HISTORIC AND DESIGN REVIEW COMMISSION

August 04, 2021

HDRC CASE NO: 2021-296
COMMON NAME: Elmira at Myrtle – Lots previously addressed as 1212, 1216 and 1218 E Euclid; 813, 823 and 825 E Myrtle, and 818 E Locust
LEGAL DESCRIPTION: NCB 6792 BLK 4 LOT 28 29, 40 & N 15 FT OF 30
NCB 6792 BLK 4 LOT 7&8 9, 34, 35, & 36
NCB 6792 BLK 4 LOT 32 33, 41, 42 & S 15 FT OF 31
NCB 6792 BLK 4 LOT 19 20 & 21
ZONING: IDZ-3, RIO-2
CITY COUNCIL DIST.: 1
APPLICANT: Cameron Kraus/Gensler
OWNER: Jim Young/SABOT DEVELOPMENT
TYPE OF WORK: Construction of a 10-story mixed use tower
APPLICATION RECEIVED: June 18, 2021
60-DAY REVIEW: Not applicable due to City Council Emergency Orders
CASE MANAGER: Edward Hall

The applicant is requesting a Certificate of Appropriateness for approval to construct a 10-story, mixed use structure to feature 229 residential units and first floor retail. The applicant has noted structured, on-site parking for both residential and retail uses. The proposed new construction is located on the lots bounded by E Euclid, E Myrtle, E Elmira, and E Locust; however, it excludes the lots at the corner of E Myrtle and E Elmira. The proposed new construction is located within RIO-2 and will

RESIDENTIAL
SETBACK

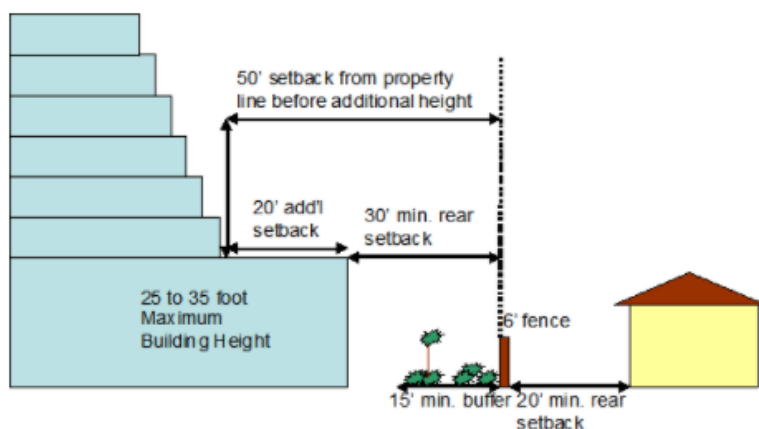
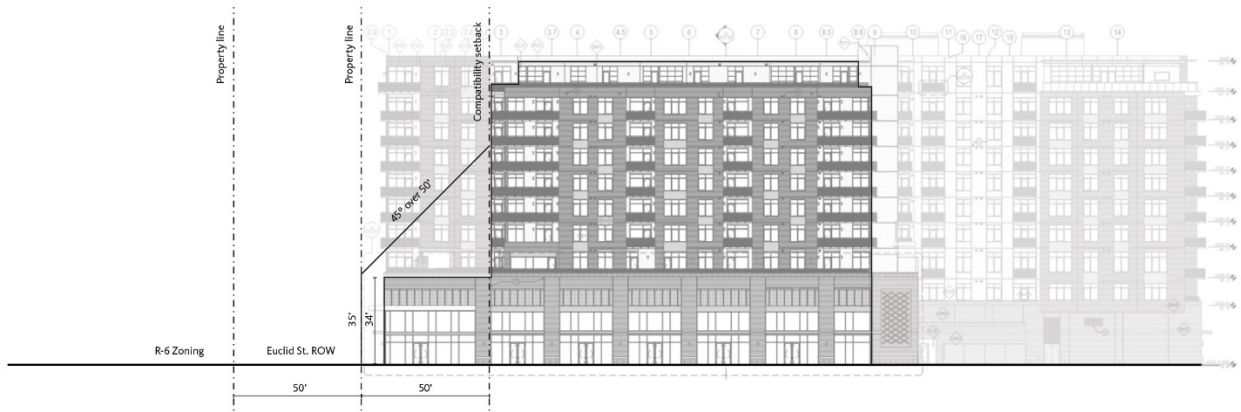
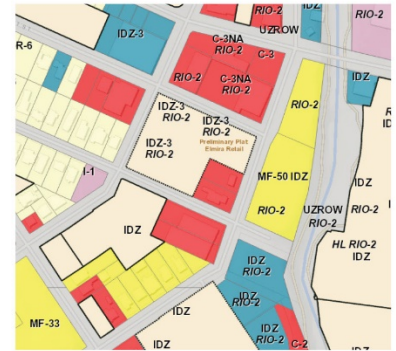
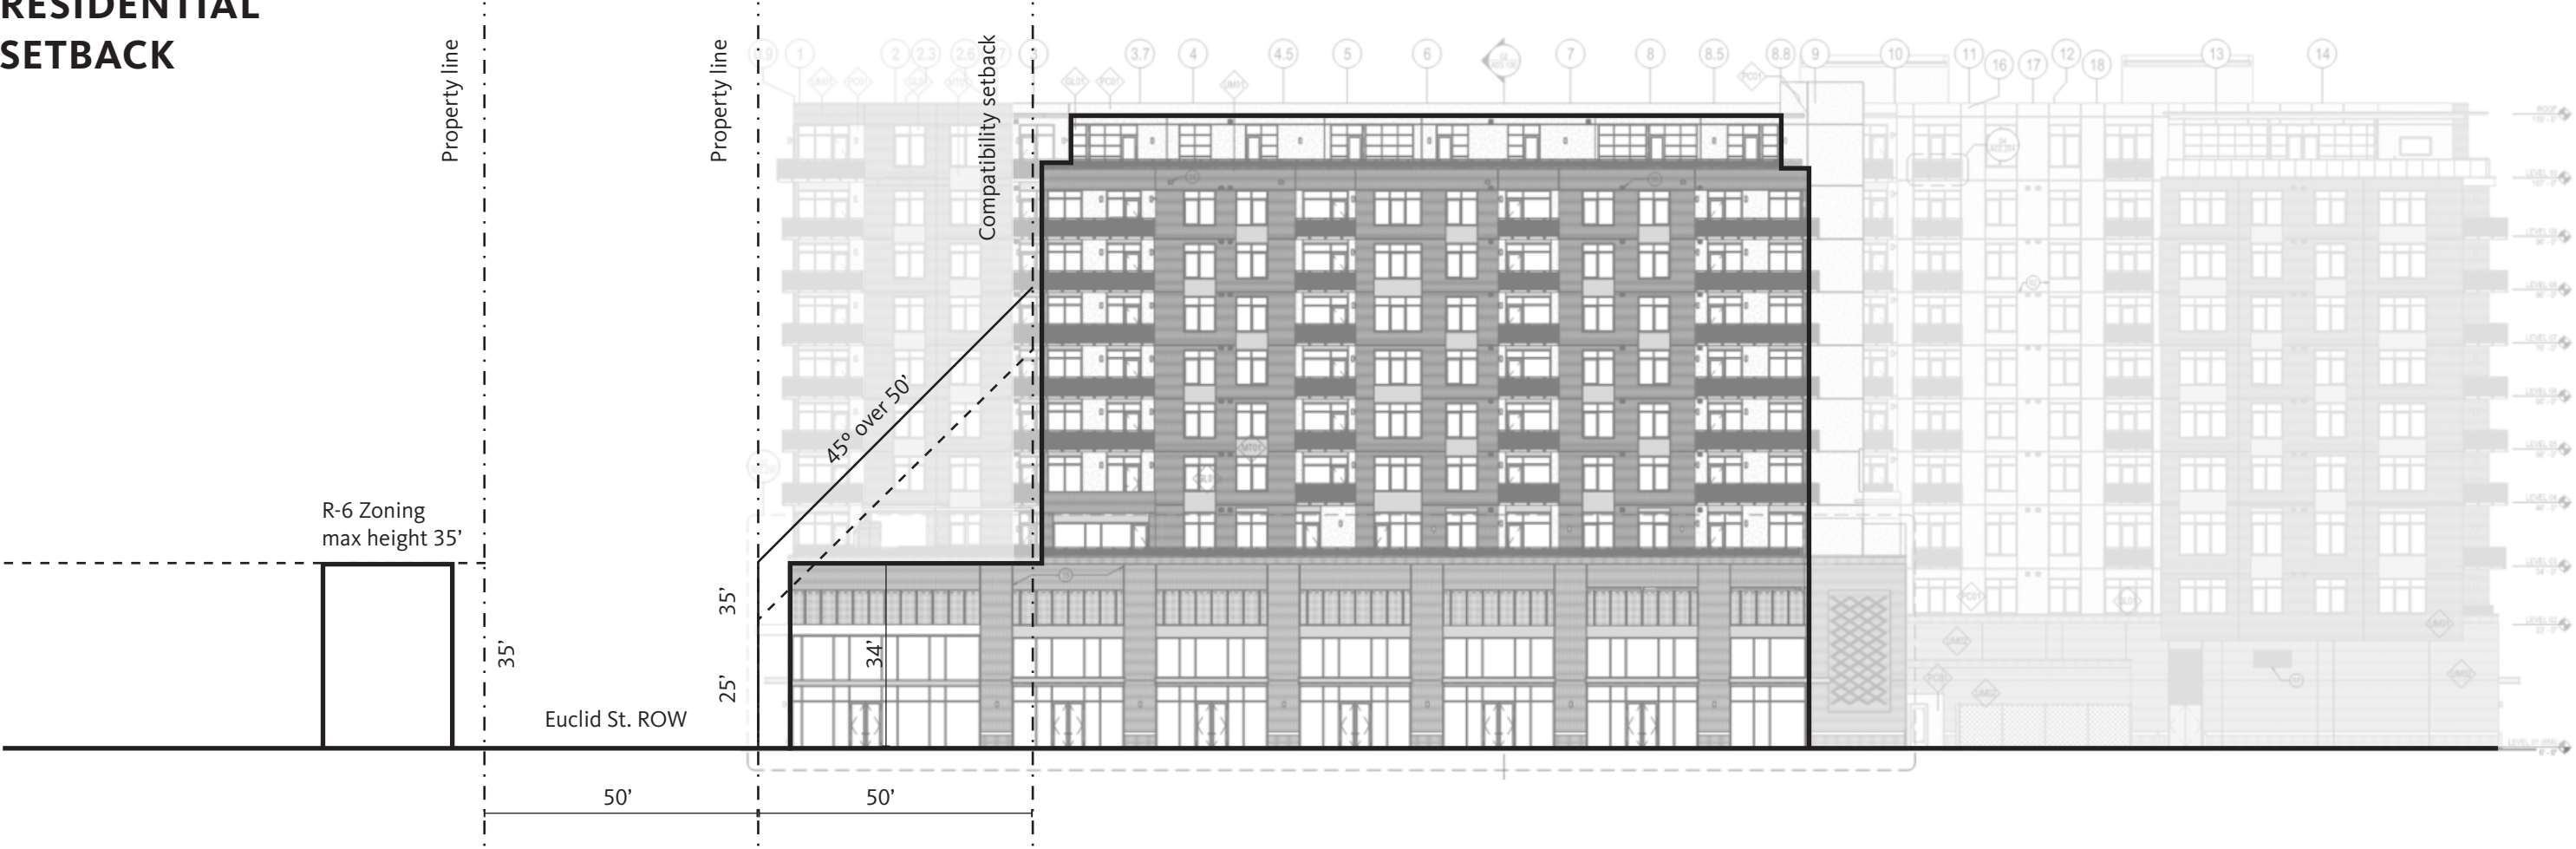
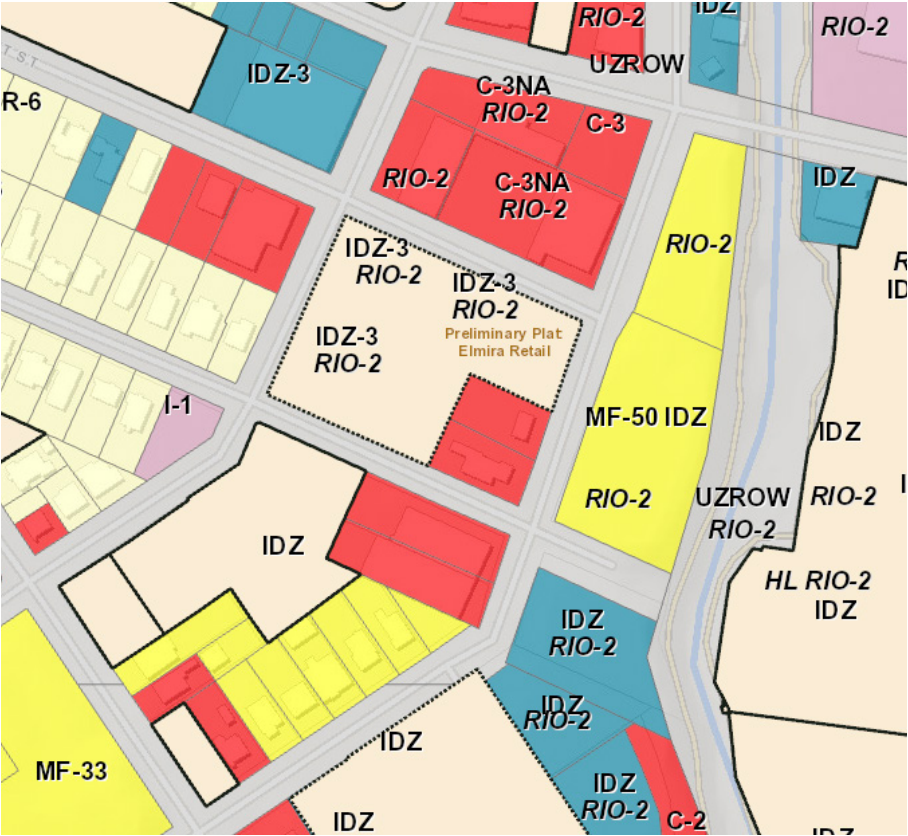
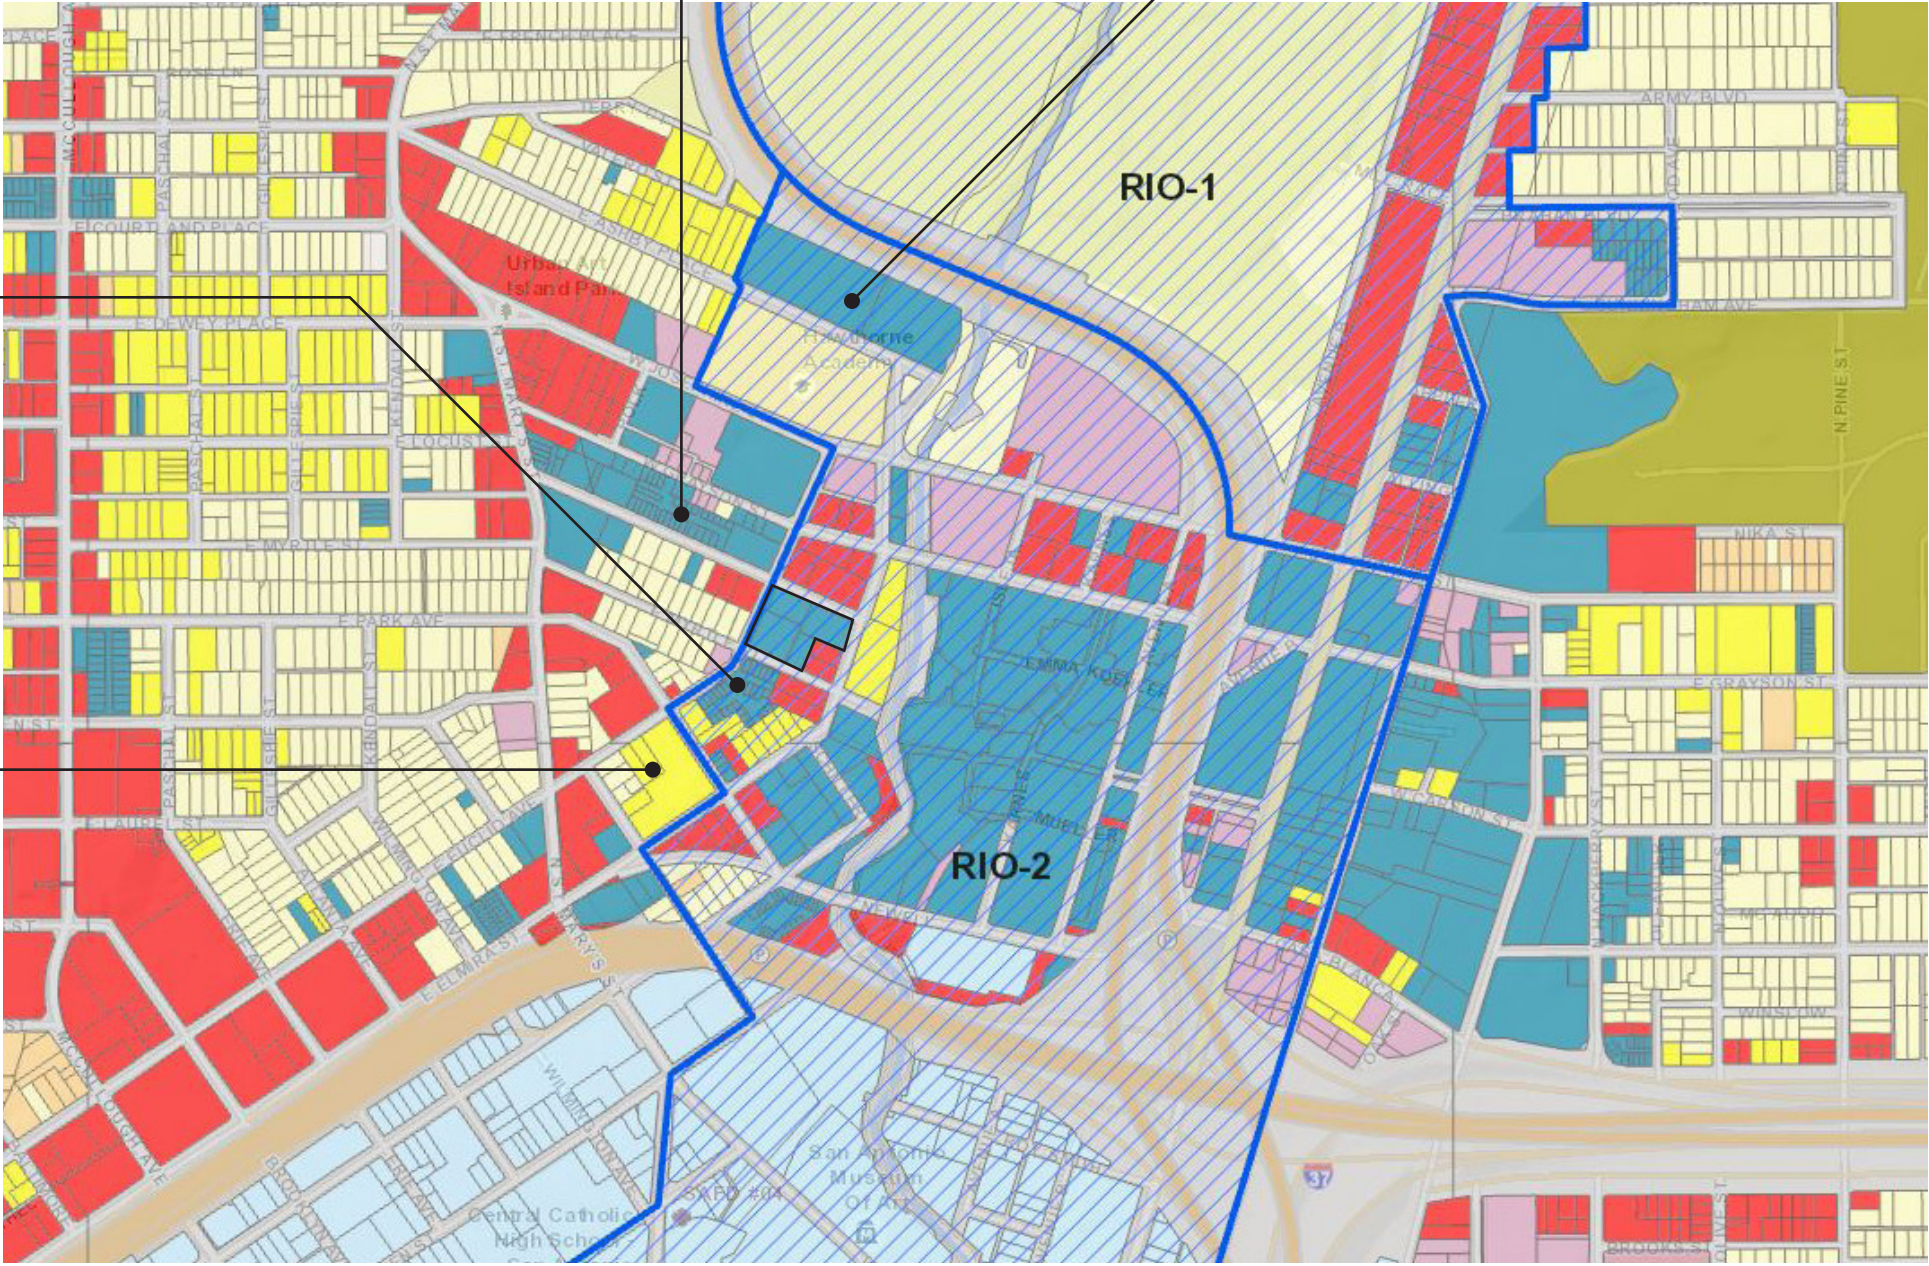
- iv. That the applicant submit provide a dimensioned elevation and a transition diagram to note compliance with the UDC in regards to building height at the setback line. **The applicant has submitted a dimensioned elevation and transition diagram. Refer to finding h.**

iv. That the applicant submit provide a dimensioned elevation and a transition diagram to note compliance with the UDC as noted in finding m.

35' max height consistent with neighboring IDZ new construction which abuts R-6 zoning

This is consistent with neighboring new construction, IDZ, which likewise abuts R-6 zoning on the SW corner and maintains this 35' max building height across the street.

35' max height consistent with neighboring IDZ new construction which abuts R-6 zoning as well as possible development on the R-6 parcels

Typical Window Detail

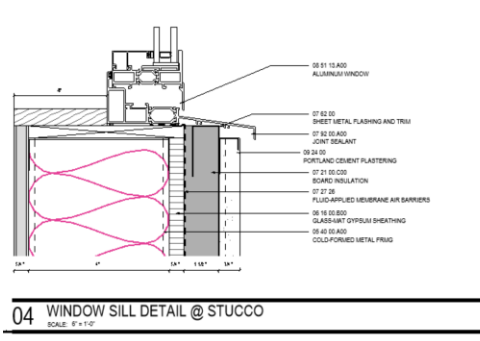
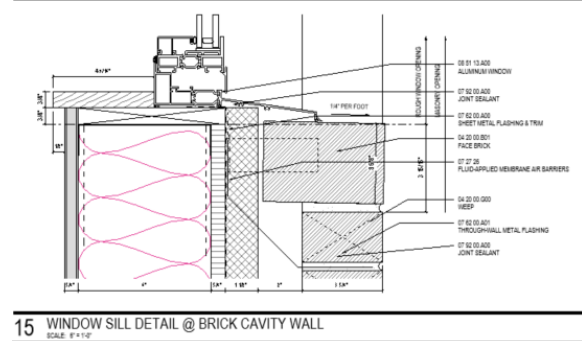
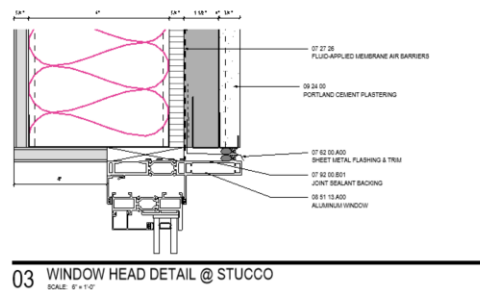
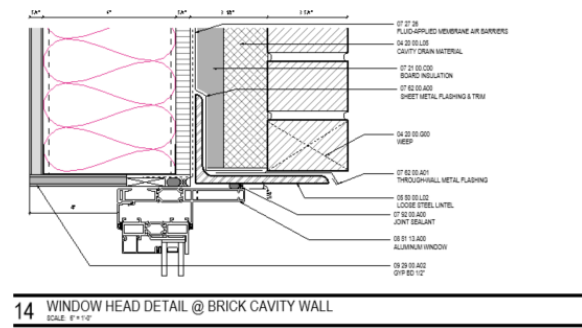
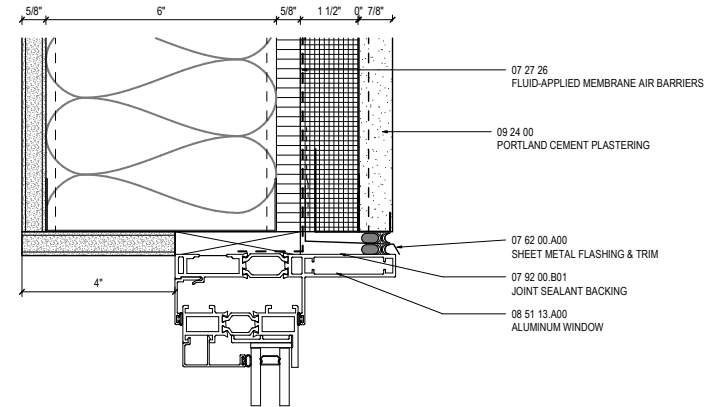
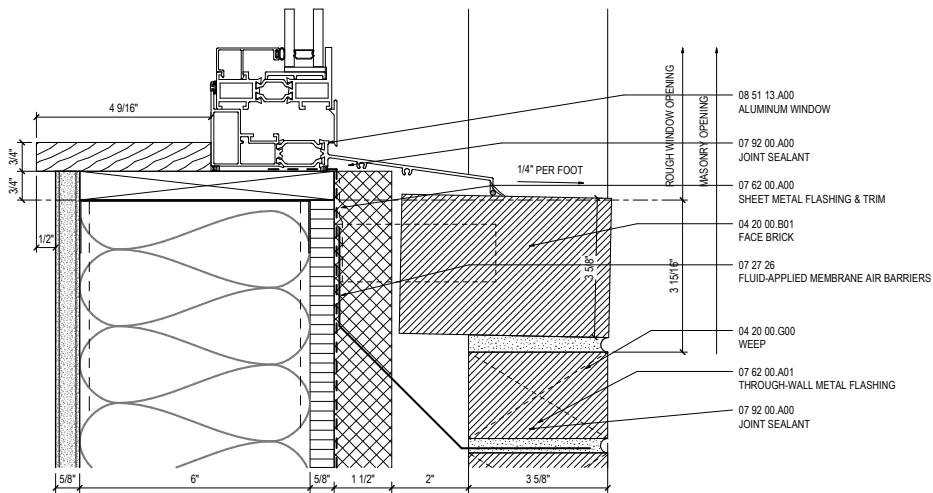
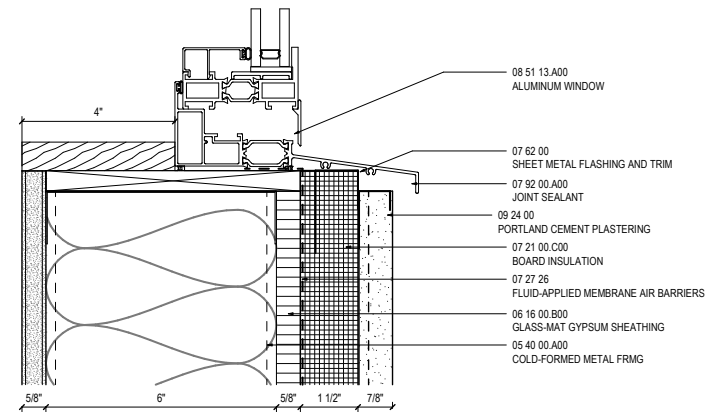
- v. That the applicant incorporate additional façade separation at the street level on the southeast façade.
 - vi. That the applicant recess all windows at least two inches within façade planes and that all windows feature dark colors. **The applicant has submitted window installation details noting compliance with this requirement.**

vi. That the applicant recess all windows at least two inches within façade planes and that all windows feature dark colors as noted in finding q. Window specifications should be coordinated with staff prior to a request for final approval.

Arcadia TC-470 Series window, dark bronze

East Elevation

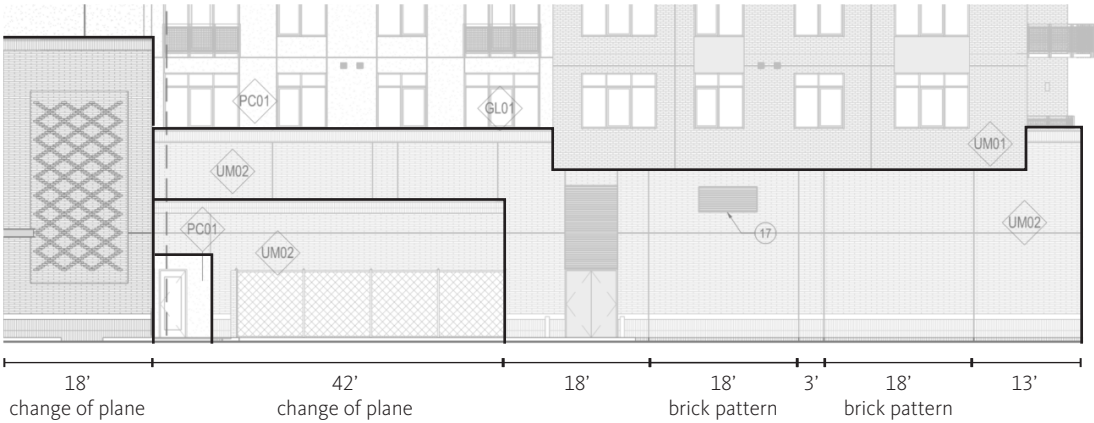
v. That the applicant incorporate additional façade separation at the street level on the southeast façade of the structure as noted in finding o.

Articulation along the non-street-facing facades is expressed through the continuation of brick masonry materiality which breaks down the scale as well as the addition of jogs (in plan) and stepping/overhanging (in elevation) in the podium massing to break up longer walls. Brick on the South courtyard wall is articulated in a diamond pattern within recessed brick frame.

Openings provide natural ventilation for the garage and a structural rhythm on the East facade.

Various steps and an overhang provides visual interest and complexity

Brick materiality wraps into the alley and non-street facing facades to continue a human-scaled material expression even in these back-of-house areas.
